in the matter of: proposed Plan Change 14 to the Christchurch District
Plan

and: **Carter Group Limited**
(Submitter 824)

Statement of evidence of Lisa Williams (Transport Engineering) on
behalf of Carter Group Limited

Figure 1: Miss-alignment between minimum access width and maximum vehicle crossing widths (even if splayed – yellow dotted lines).

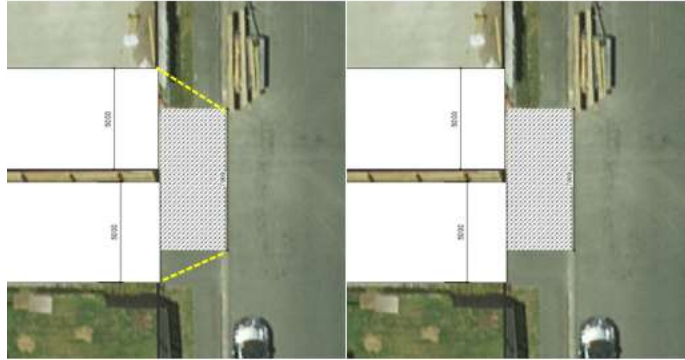
- 16 My second point of concern is that the 7m maximum vehicle crossing width (proposed rule 7.4.3.13. b) directly conflicts with the minimum access width and queuing space requirements in Rule 7.4.3.7. The proposed rule also creates a "first in first served" situation which may leave neighbouring sites with no complying vehicle crossing location. Several examples are provided below.

Figure 4: Two examples of sites left with no permitted or impractical vehicle crossing locations.

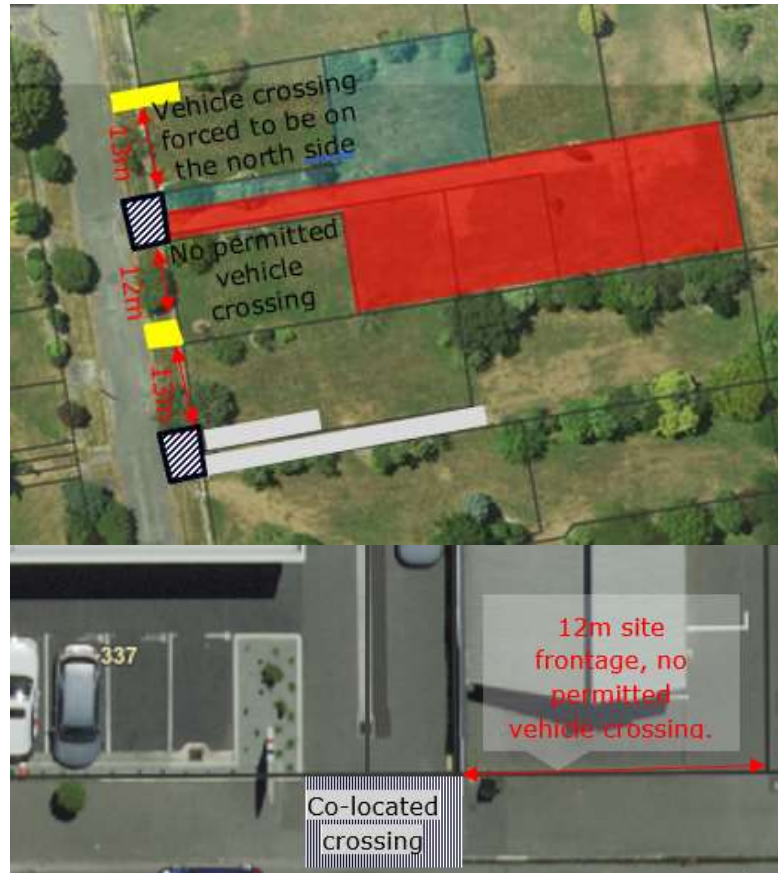
- 19 My third point of concern is that the proposed rule also requires 13m between a co-located vehicle crossing and another vehicle crossing. Many sites have narrow road frontages such that the proposed rule will leave some neighbouring sites with no compliant vehicle crossing location. It could also force a vehicle crossing to be provided in a less desirable location for the development of the site or in direct conflict with other rules such as separation from intersections. Several examples are provided in Figure 4.

21 As such I recommend that the requirement for separation between co-located vehicle crossings is amended as follows:

*c. the minimum distance between a shared vehicle crossing and any other **shared** vehicle crossing shall be **131.8m**.*
